**Subject: Response to Portion of NRC Request for Additional Information
Letter No. 53 Related to ESBWR Design Certification Application –
DCD Chapter 4 and GNF Topical Reports – RAI Numbers 4.3-2, 4.3-
5, 4.4-25, 4.4-30, 4.4-35, 4.4-39, 4.4-51**

Partial Response to RAI Letter No. 53 Related to ESBWR

DCD Chapter 4 and GNF Topical Reports

RAI Number 4.3-2, 4.3-5, 4.4-25, 4.4-30, 4.4-35, 4.4-39, 4.4-51

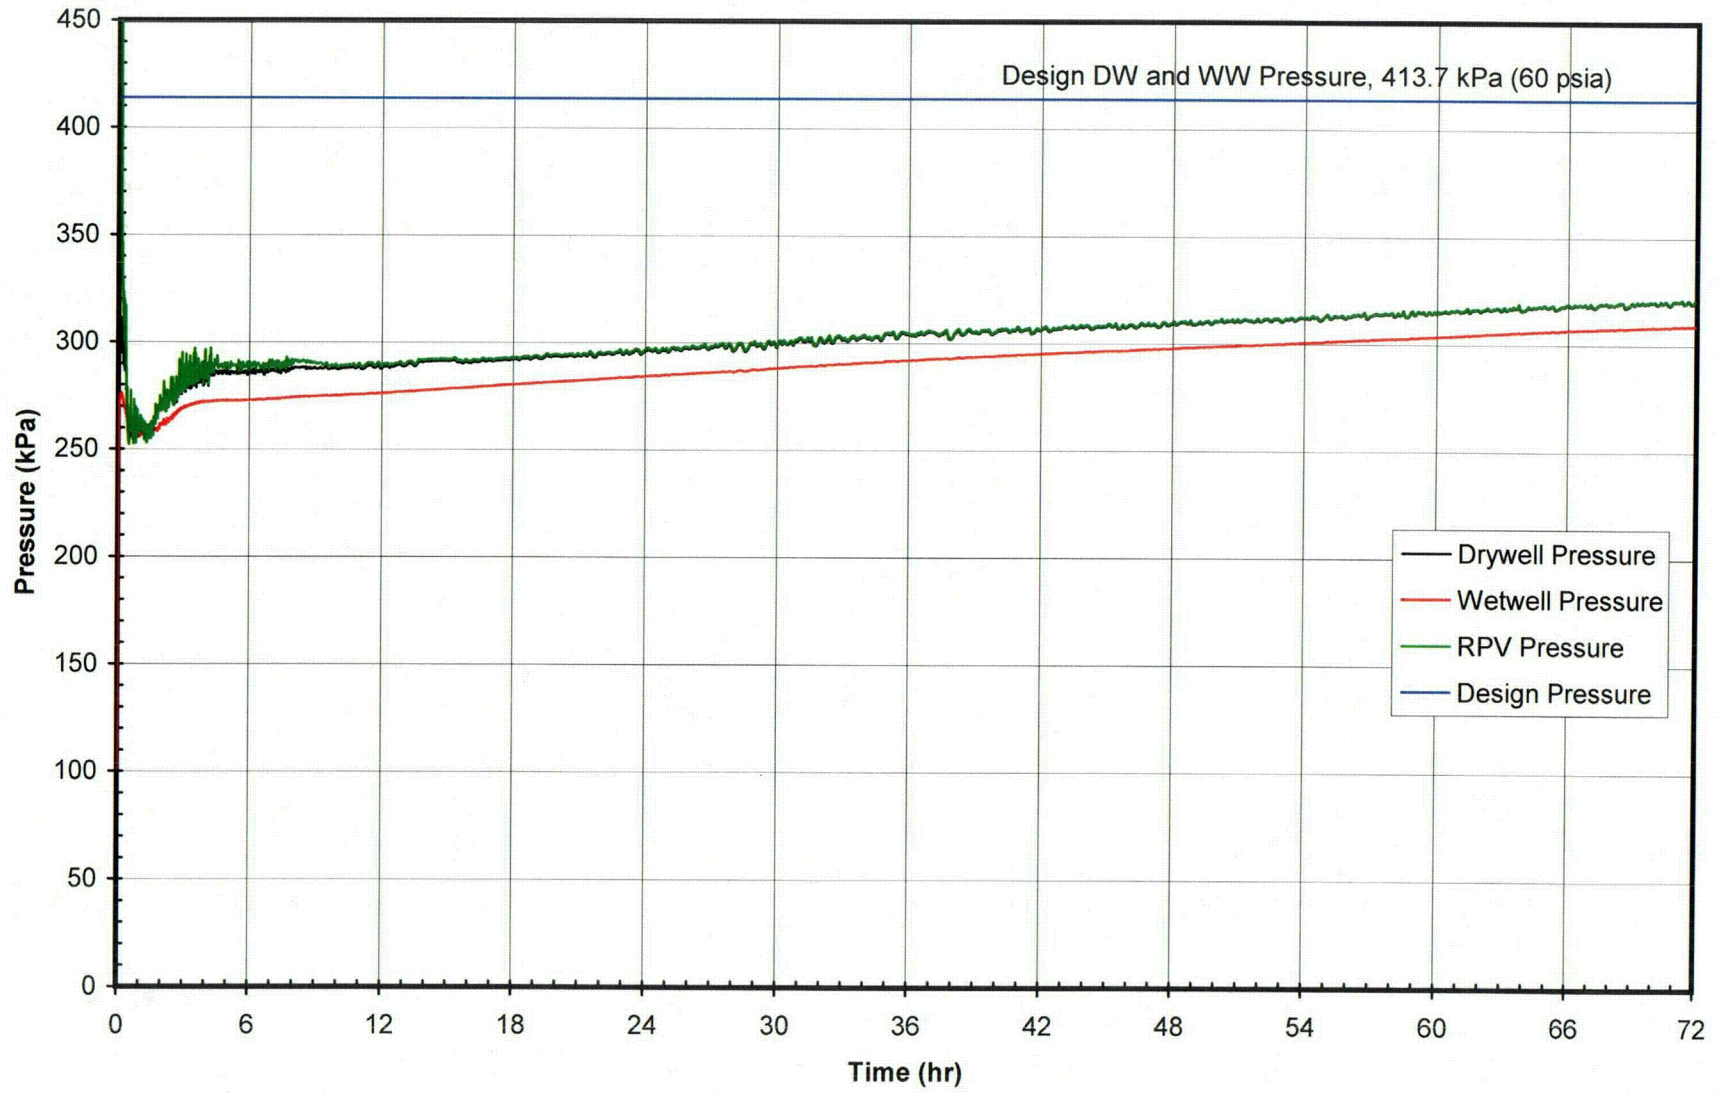
Section 3.1.2.1 of NEDC-33239P discusses bundle peaking. Are the bundle peaking values (both fuel pin and bundle) lower for the GE14E bundles? How do these compare to ABWR and BWR/6 values?

Section 3.1.2.1 of NEDC-33239P is meant to call attention to the lattice power peaking characteristics within the bundle. The ESBWR core is comprised of assemblies in an N-lattice configuration. There is nothing inherent in the ESBWR fuel that results in the pin power peaking being either lower or higher than in other plant types.

The N-lattice is applied to both the ABWR and the ESBWR and is similar to the C-lattice (GE BWR-4C and BWR-5C plants) in that the bundle pitch is evenly centered within the core with equal intra-assembly gap widths; although, the size of the intra-assembly gaps are larger owing to the slightly larger bundle pitch (6.1" for the N-lattice and 6.0" for the C-lattice). For contemporary GNF fuel, the S-lattice, which denotes the geometry of the BWR-6, is identical to the C-lattice. Note that the fuel assembly lateral geometry is otherwise identical between the N-lattice and the C-lattice. Given the slightly larger intra-assembly gaps in the N-lattice, the thermal neutron flux is relatively higher on the edge and therefore the 2D pin power peaking can be relatively higher as compared to the C-lattice geometry, all other factors being equal (such as enrichment and gadolinia distributions). In contrast, the D-lattice (GE BWR-2D, BWR-3D and BWR-4D) has asymmetric intra-assembly gap widths, with the gaps on the control blade sides being larger than that of the N-lattice. This results in increased thermalization of the neutron flux in this gap and higher edge rod pin power peaking for the D-lattice as compared to both the C-lattice and the N-lattice. To illustrate the magnitude of these different characteristics, ESBWR Reference lattice 81803 was analyzed in N-lattice, C-lattice and D-lattice configurations. The results of these lattice physics calculations at 40% in-channel void fraction, and void history, are illustrated in Figure 4.4-51-1.

It should be noted, that there is significant flexibility to achieve a target pin power peaking through nuclear design (e.g. enrichment and gadolinia distribution) and maximum pin power peaking at BOL typically ranges from [[]] depending on the design application.

To summarize ESBWR lattice peaking characteristics, the N-lattice exhibits edge rod peaking that is slightly higher at BOL than C-lattice cores and is slightly lower than D-lattice cores; however, the nuclear design of the lattice has a much more significant influence on maximum pin power peaking.

The bundle power peaking is not an attribute of the reactor core except that core size can influence inherent peaking somewhat (i.e. small cores tend to have larger flux gradients and higher bundle peaking as compared to large cores, all else being equal). Rather, it serves as a design parameter that can be adjusted in order to maintain compliance with thermal limits. The core average power density, bundle power peaking, axial power

peaking and lattice pin power peaking all combine in the determination of LHGR. The ESBWR core has a moderate power density and can accommodate high power peaking values and maintain compliance with thermal mechanical LHGR limits. The core average power density, bundle power peaking and coolant flow rate are important parameters affecting MCPR. As the ESBWR coolant flow is lower than that for a typical forced circulation BWR, the maximum assembly power that provides adequate MCPR margins is lower than most forced circulation BWRs; although, the mild transient response and low OLMCPR offsets this some. As can be seen from ESBWR DCD Tier 2, Section 4.A, maximum bundle power peaking values vary between [[]]. In contrast, a low power density (~40 KW/L) forced circulation BWR with a favorable OLMCPR could accept bundle power peaking values above [[]] while a high power density (~60 KW/L) forced circulation BWR, operating at low flow, may only be able to accept bundle power peaking values similar to the ESBWR.
